HOPE CREEK GENERATING STATION  
DOCKET NO. 50-354  
FSAR COMMITMENT STATUS THROUGH AUGUST 1984

ATTACHMENT I  
HOPE CREEK GENERATING STATION  
FSAR COMMITMENT STATUS THROUGH AUGUST 1984

QUESTION 220.21 (SECTION 3.7.2)

Figures 220.21-1 through 220.21-54 show a comparison of the 2 percent damping response spectra obtained from the design basis finite element and the impedance analyses for the reactor building, auxiliary building and the service water intake structure (SWIS).

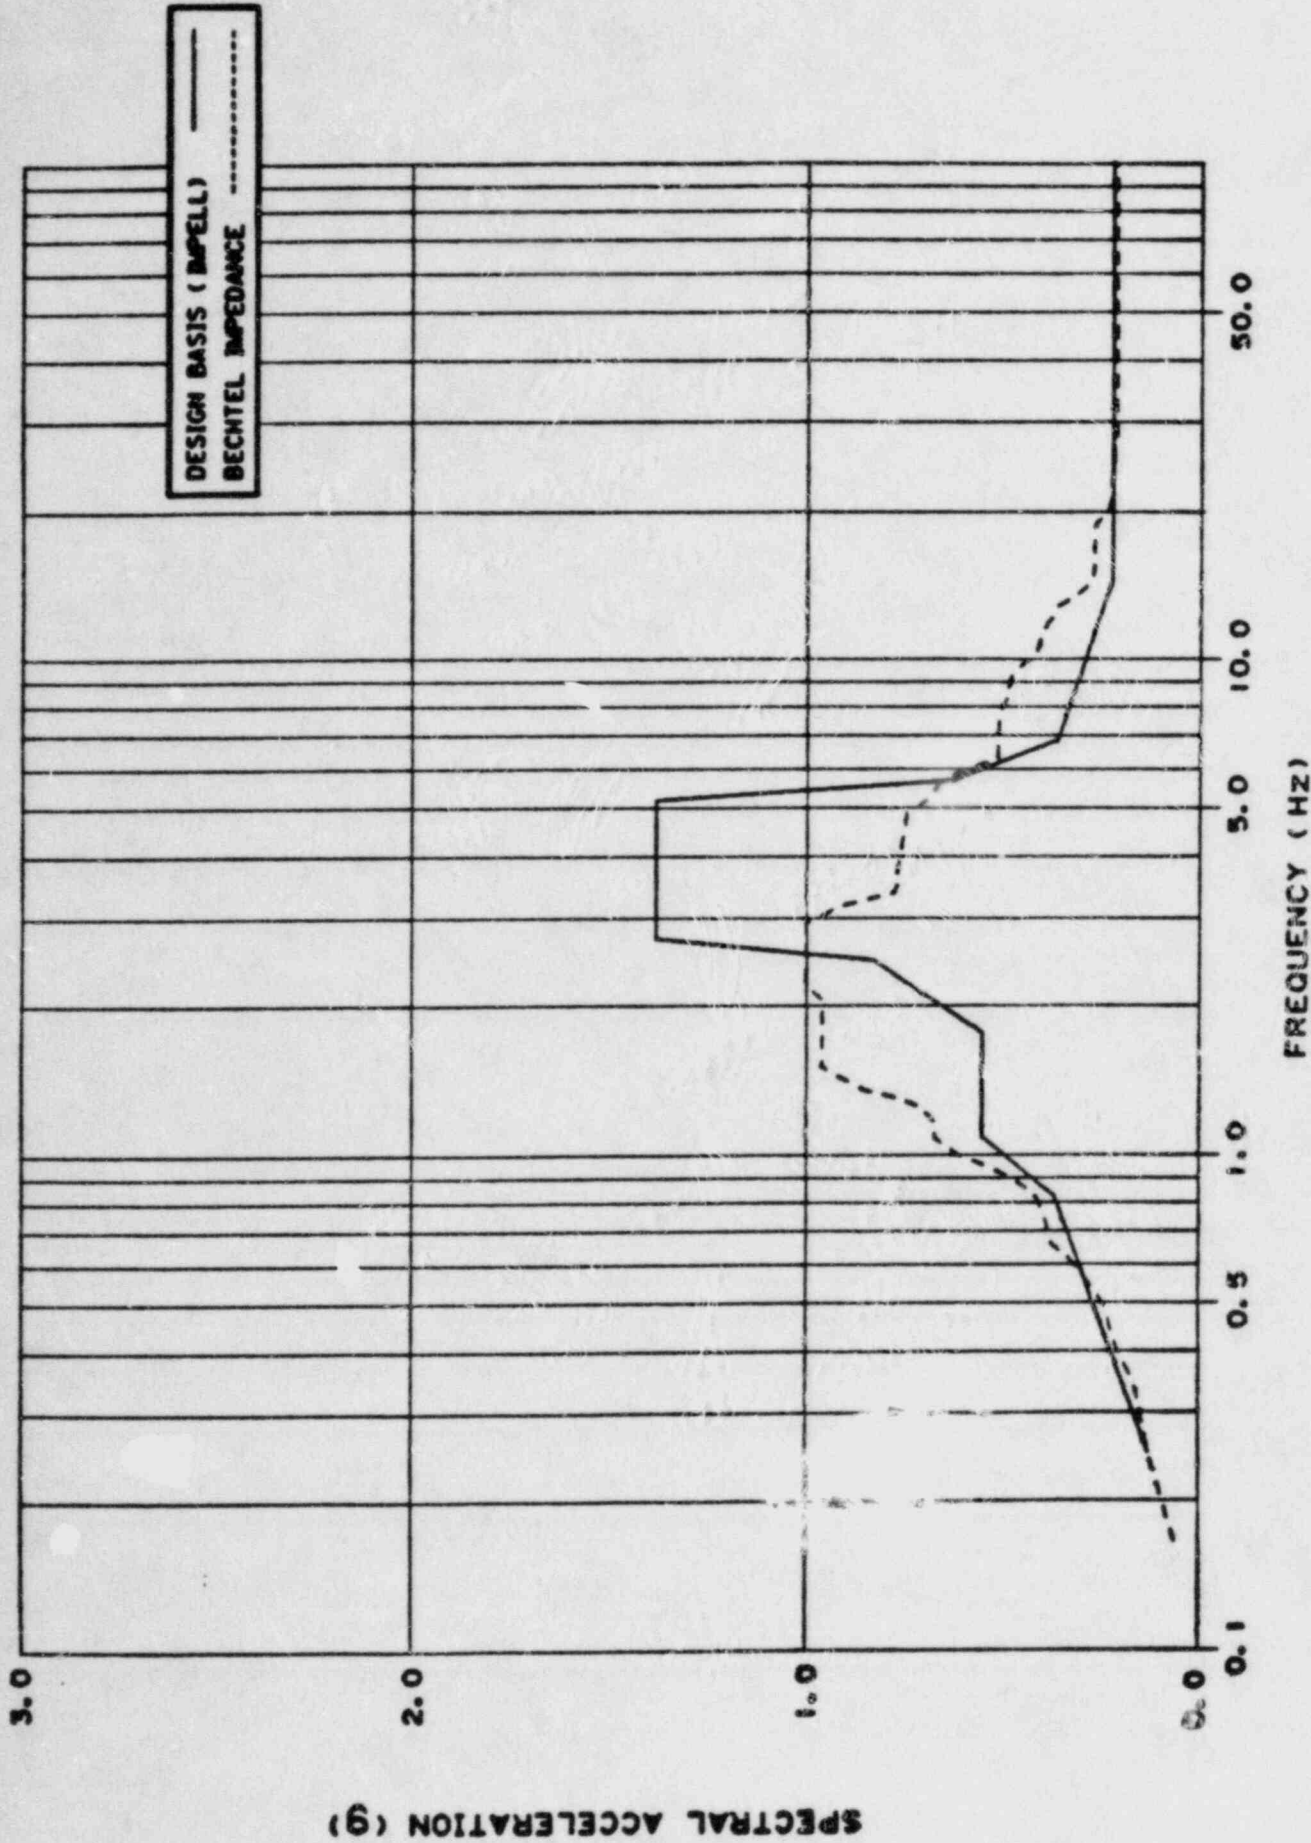
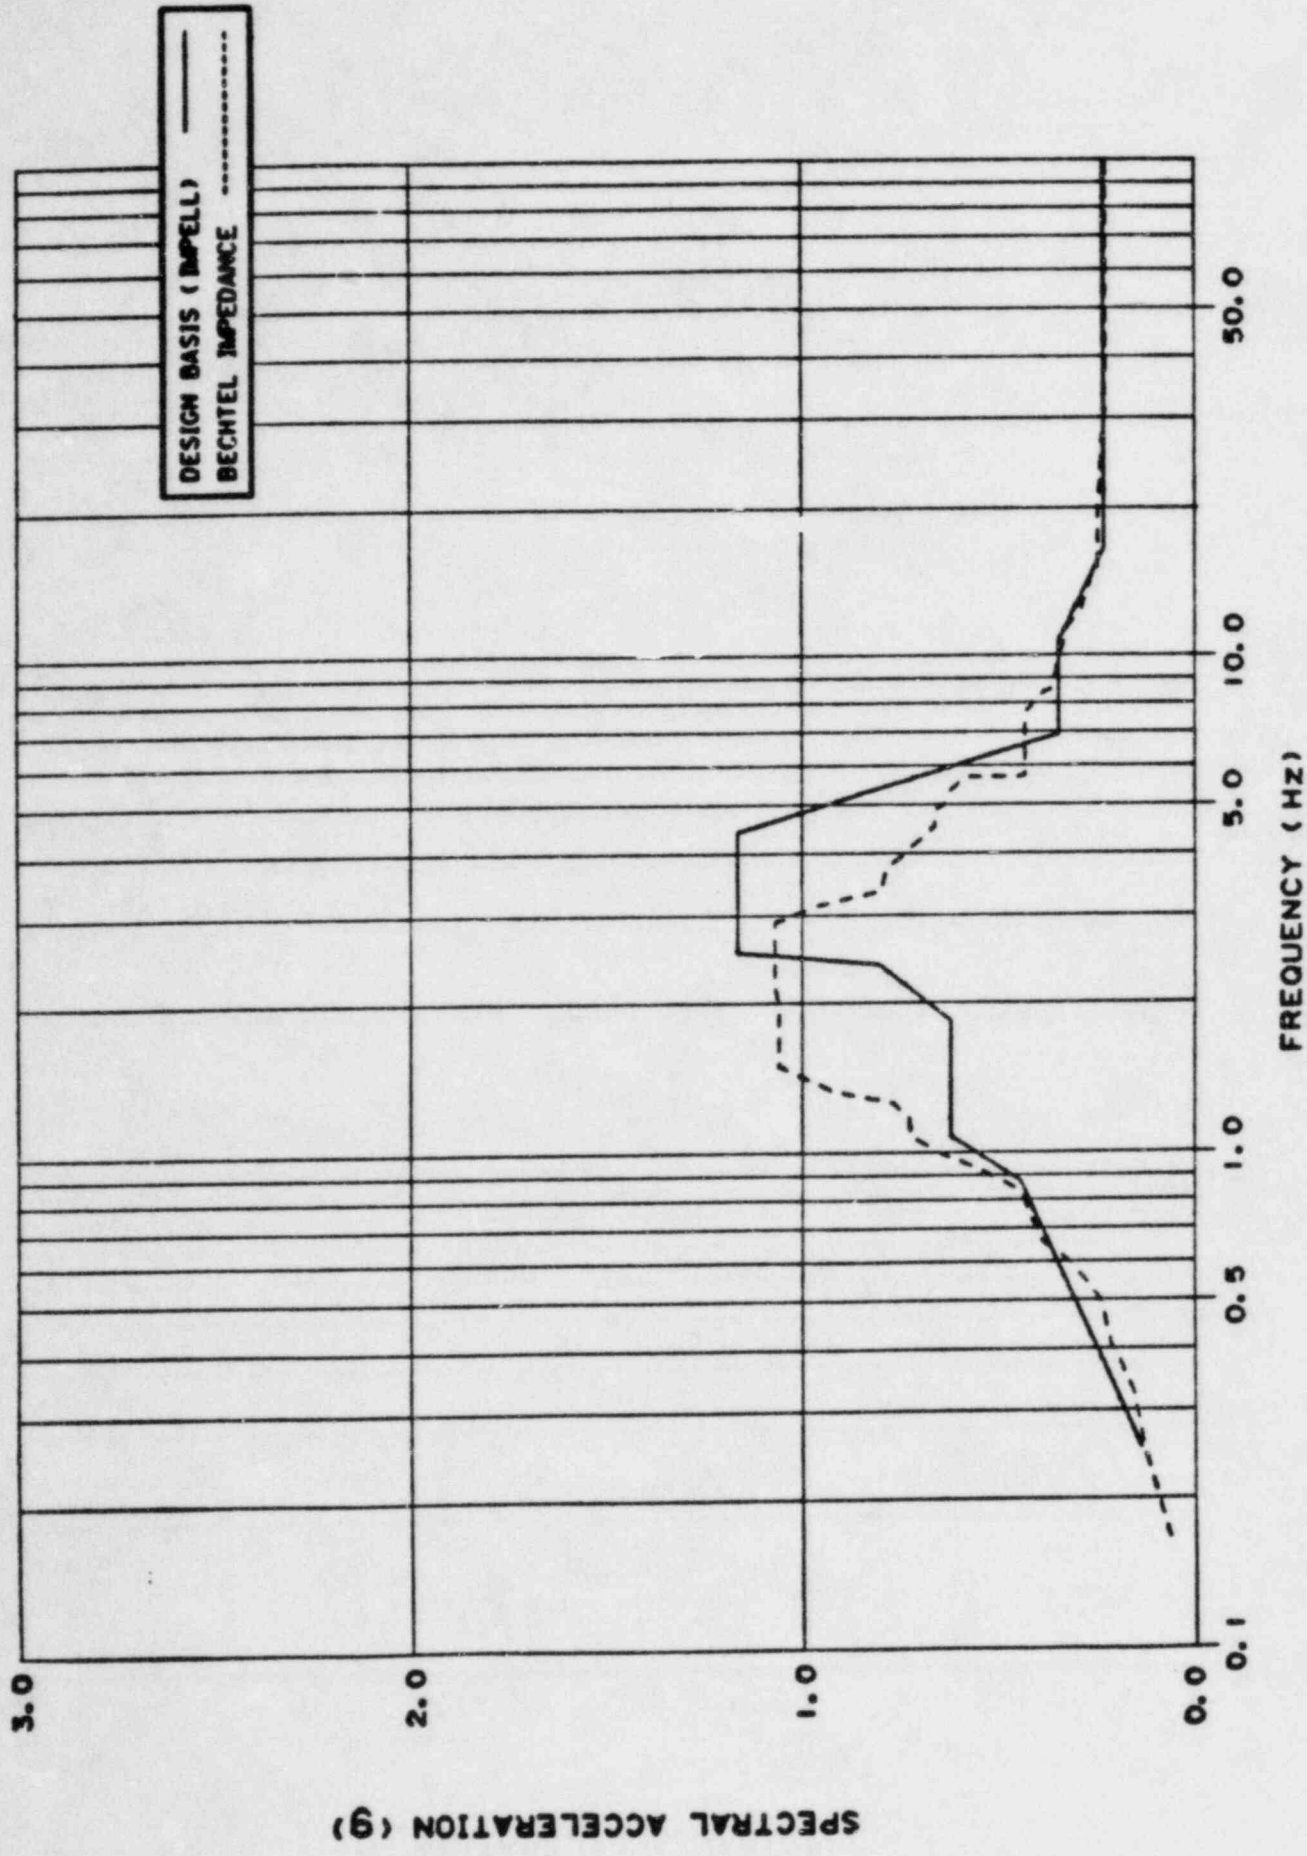
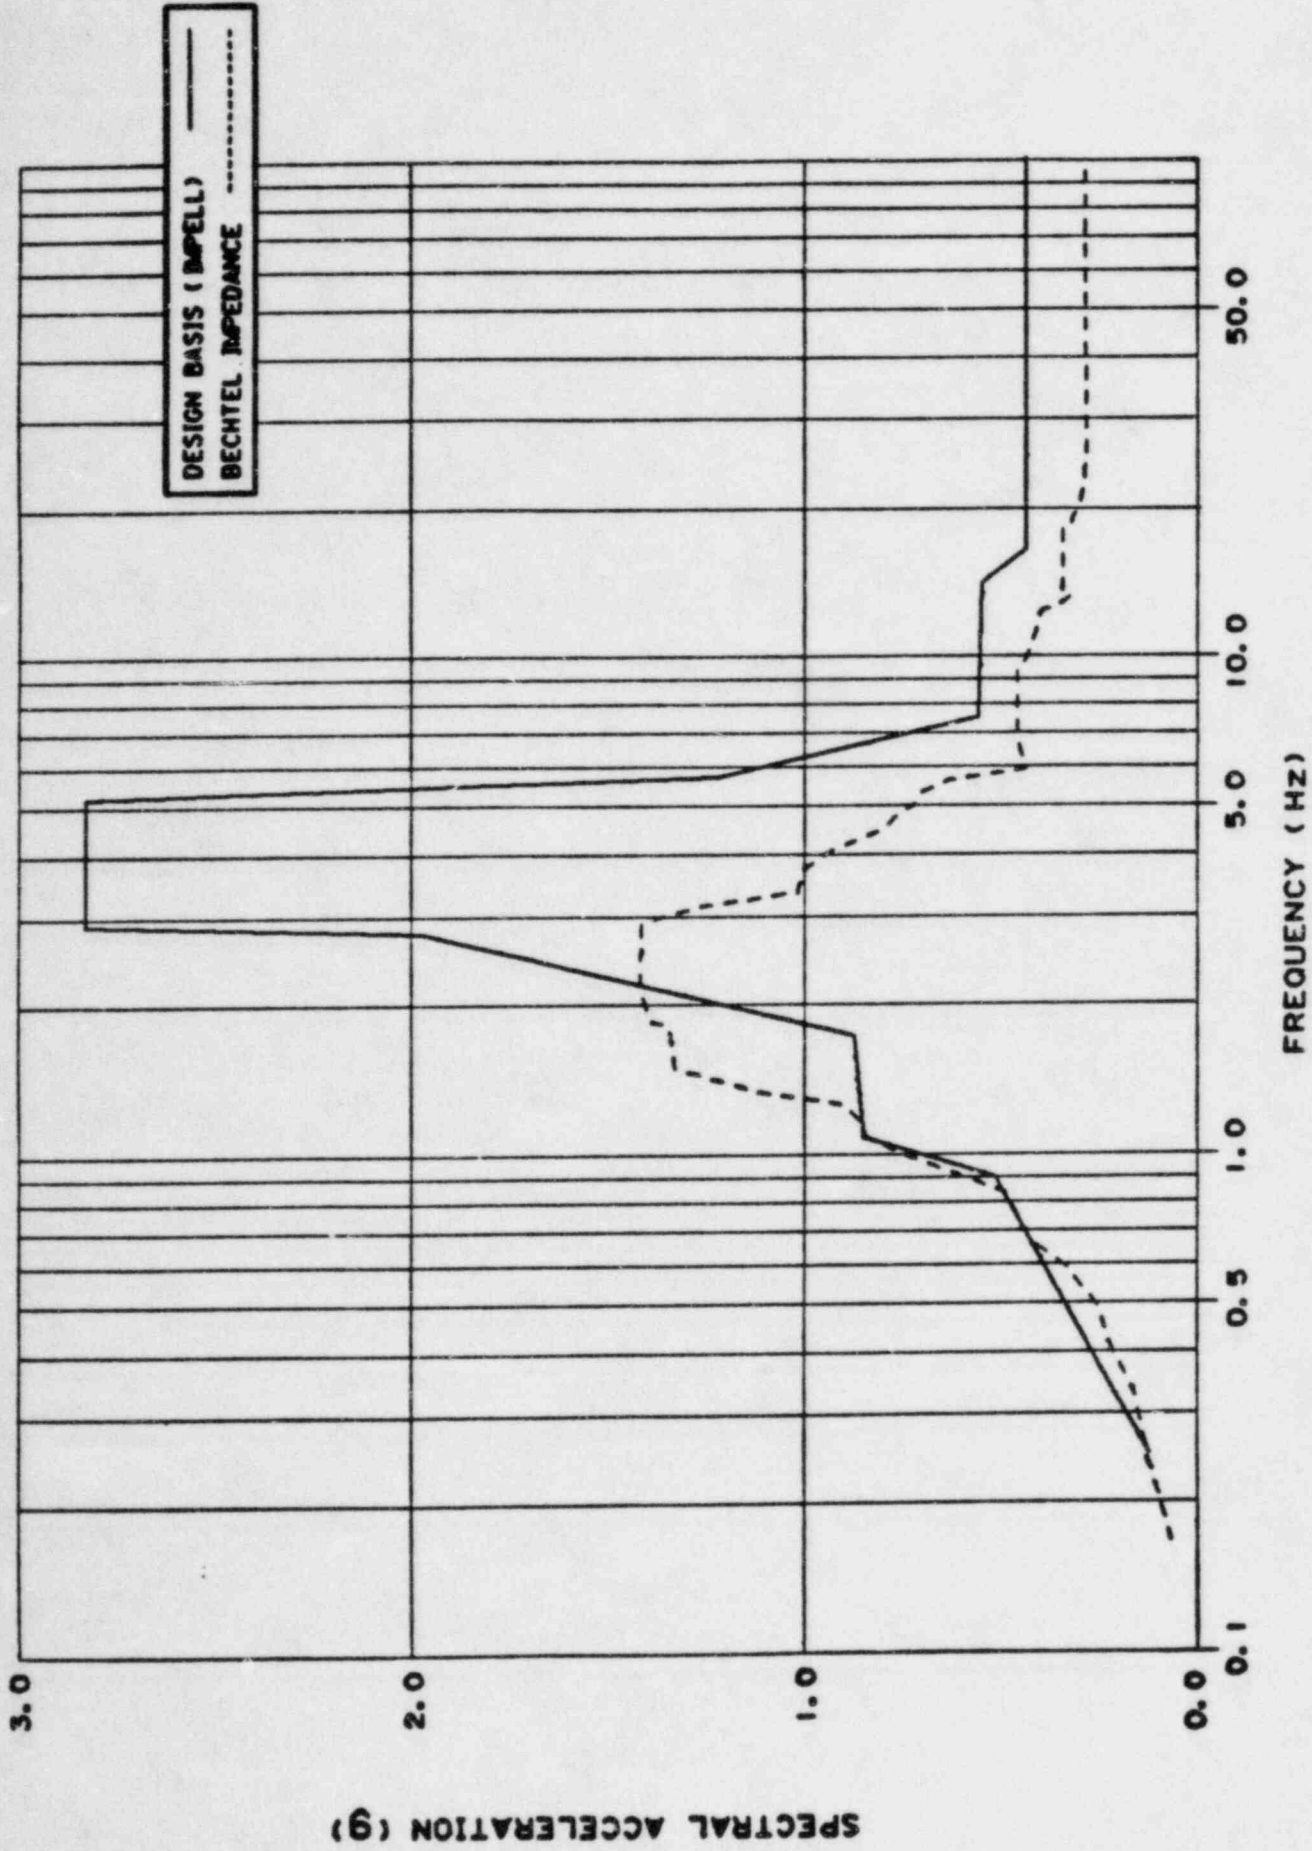
The Hope Creek soil-structure interaction analysis is performed by applying a specified earthquake input motion at the base of the finite-element model. The base level input motion is generated through a deconvolution analysis. The applicable SRP criteria for soil-structure interaction analysis require that both the half-space and finite-element approaches should be considered. (For details refer to SRP 3.7.2-11.4). Public Service should perform necessary analyses to demonstrate conformance to the criteria.

¶ For the reactor and auxiliary buildings, the peak spectral accelerations obtained from the impedance analysis are generally lower than those obtained from the design basis analysis. However, the impedance analysis response spectra are not completely enveloped by those obtained from the design basis analysis, especially in the frequency range from 1.0 to 3.5 Hz. Also, there are some local exceedances in the higher frequency range, as shown in Figures 220.21-1 through 220.21-36. ¶ For the SWIS (Figures 220.21-37 through 220.21-54), the impedance analysis response spectra are generally enveloped by those obtained from the design basis analysis at elevation 114.0 feet. For other elevations, the impedance analysis spectral accelerations exceed the design basis spectral accelerations in some frequency ranges. These ranges vary approximately between 1.5 and 10.0 Hz.

forces and moments obtained from the impedance analysis exceeded the design basis values at various locations within these buildings. The auxiliary building seismic shear forces and moments obtained from the impedance analysis are less than the design basis shears and moments.

Since the impedance analysis results are not completely enveloped by the design basis finite element analysis results, sampling studies are conducted to confirm the adequacy of the plant design. These sampling studies include an evaluation of the following items:

In all cases, the items reviewed during these sampling studies can accommodate the loads resulting from the impedance analysis. Therefore, the impedance analysis results have no impact on the plant design.
